Product Change Notification

Change Notification #: 115245 - 00
Change Title: Intel® Compute Module HNS2600TPR,
 PCN 115245-00, Product Material,
 Replacement of BMC DDR3 chip
Date of Publication: January 09, 2017

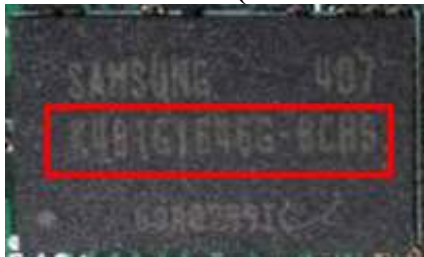
Intel is replacing the current BMC DDR3 memory chip K4B1G1646G-BCH9 (G38649-001) with new K4B1G1646I-BCK0 (J37656-001). Intel reports validation completed with passing results. The replacement component is identical in form, fit and function.
